REQUEST FOR QUOTATION Amendment #2 January 20, 2026

RFQ Name: Yale Community Park Fence

RFQ NUMBER: RFQ-26001

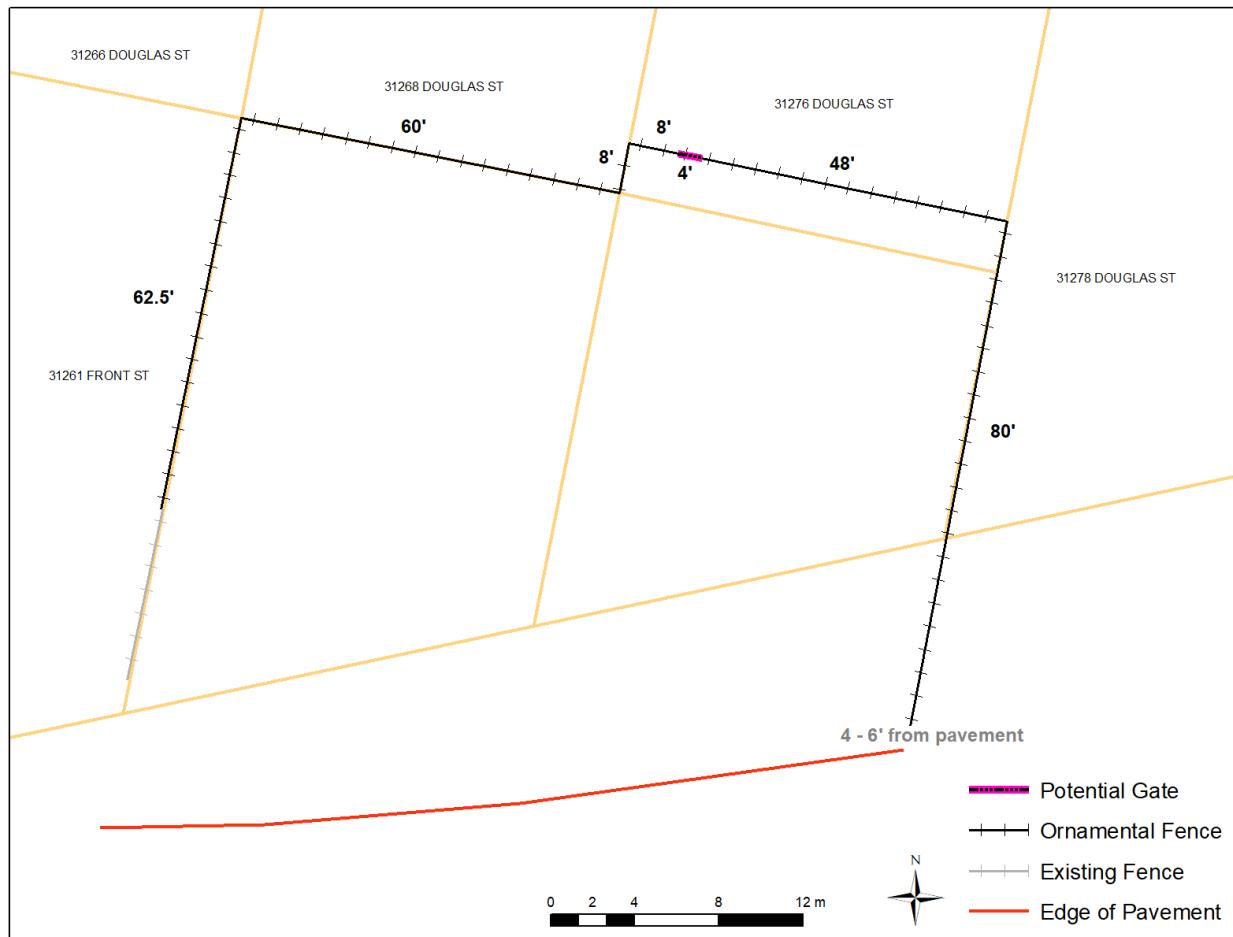
14. HOW FAR FROM THE PAVEMENT SHOULD THE FENCE BE ON THE EAST SIDE?

The start of the fence should align with the neighbouring fence, approximately 6 feet from the edge of pavement.

17. UPDATED MAP – SEE ATTACHED

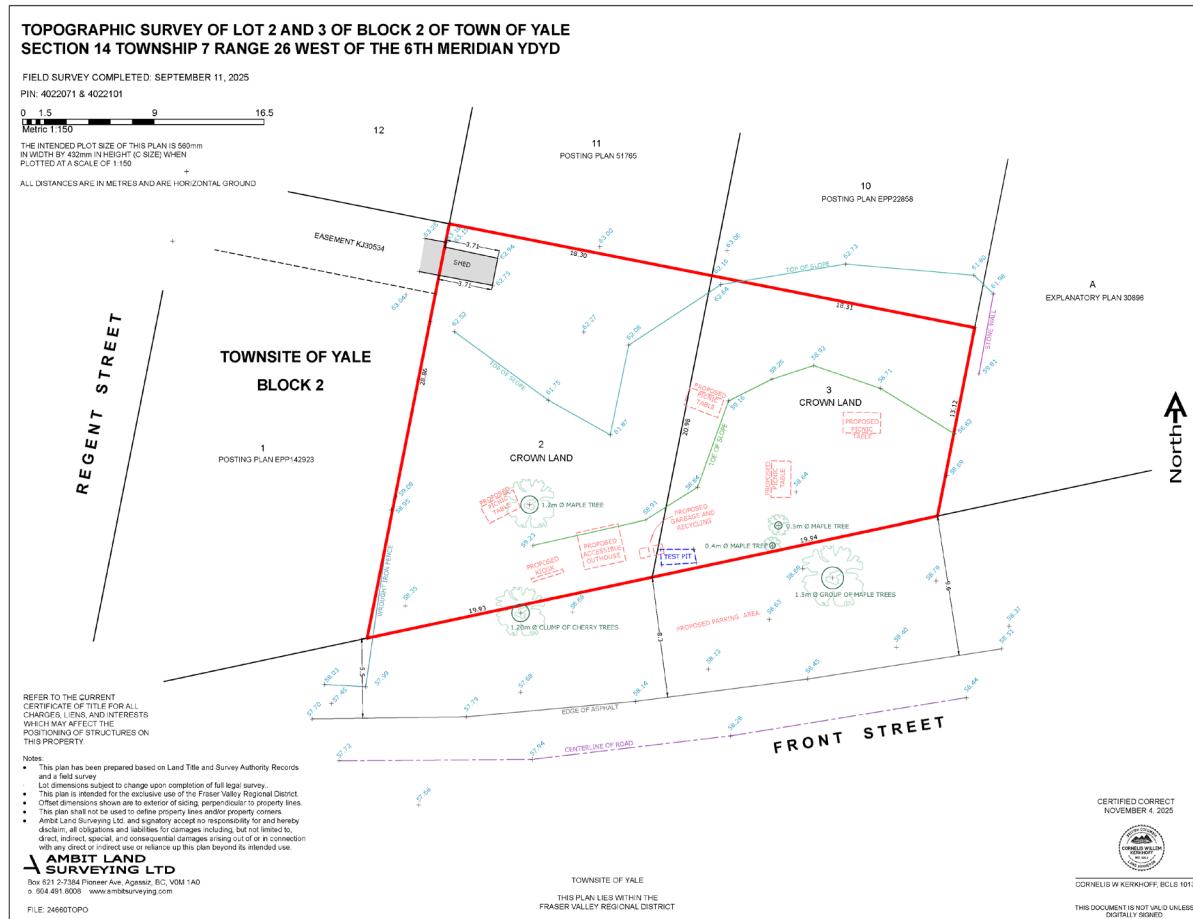
16. HOW WILL THE INTERFACE BETWEEN THE PROPERTY LINE AND THE EXISTING TREES ON THE NORTH SIDE OF THE SITE, ADJACENT TO THE HISTORIC AREA, BE ADDRESSED?

The fence alignment has been shifted approximately 8 feet from the property line to accommodate the existing trees. This adjustment allows the fence to be installed on flatter ground and avoids interference with the trees.

**TOPOGRAPHIC SURVEY OF LOT 2 AND 3 OF BLOCK 2 OF TOWN OF YAL
SECTION 14 TOWNSHIP 7 RANGE 26 WEST OF THE 6TH MERIDIAN YDYD**

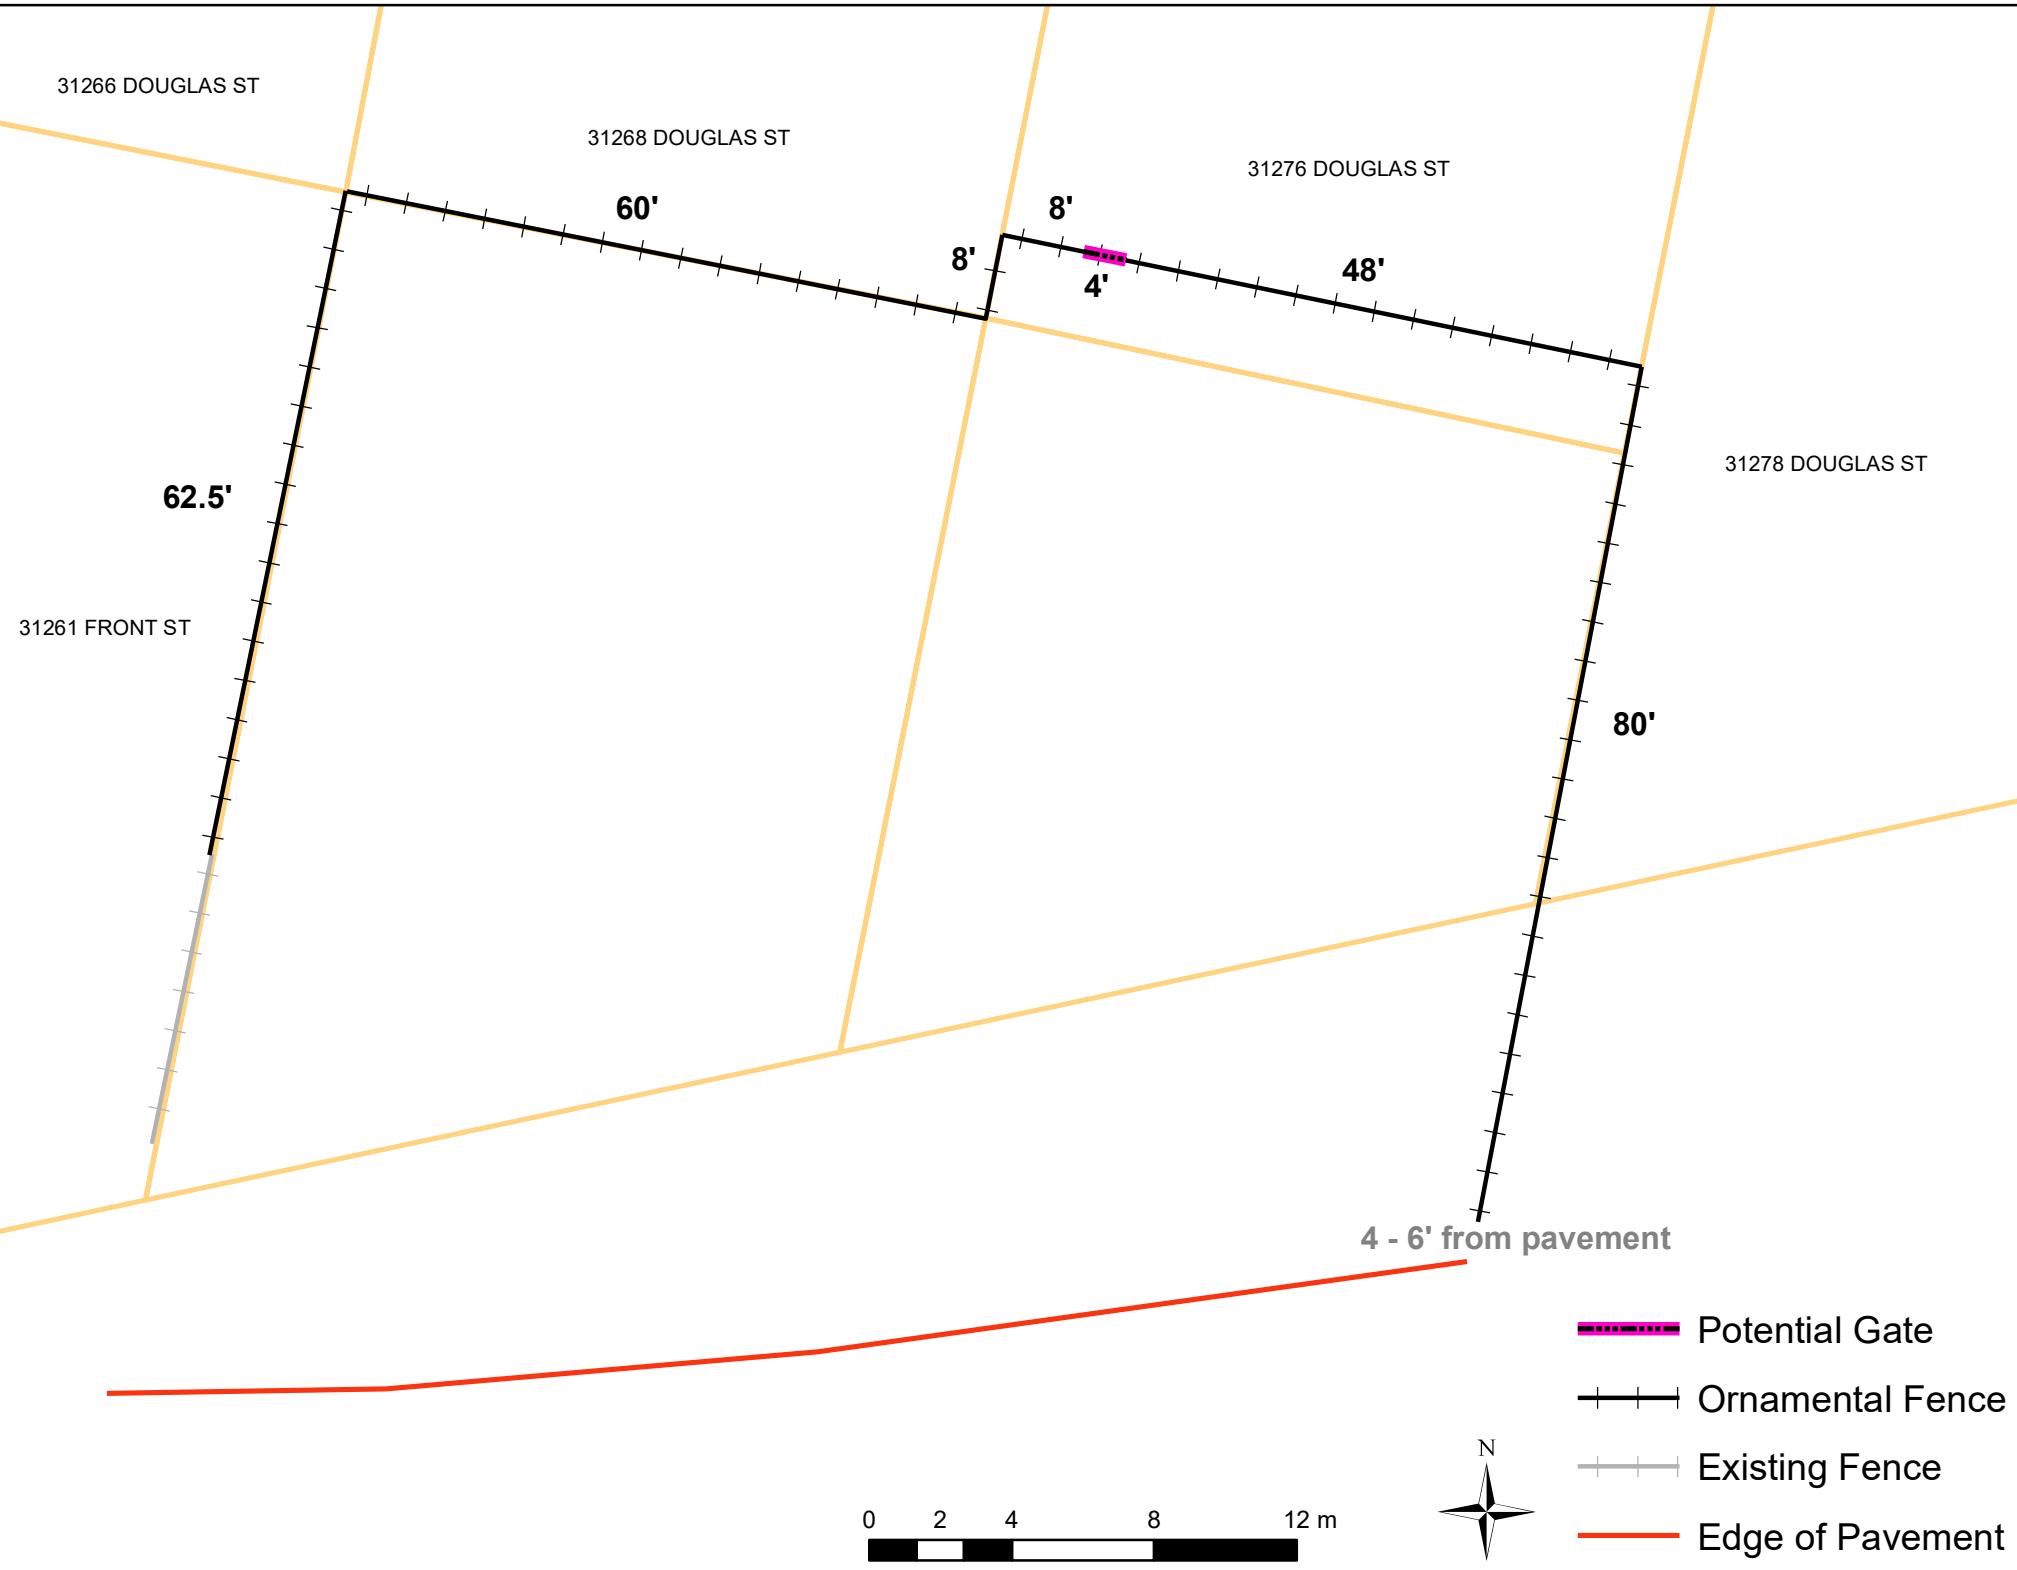
18. TOPOGRAPHIC SITE SURVEY – SEE ATTACHED

Please note that this survey was completed on September 11, 2025, and site conditions may change as grading work will occur prior to fence installation in February.
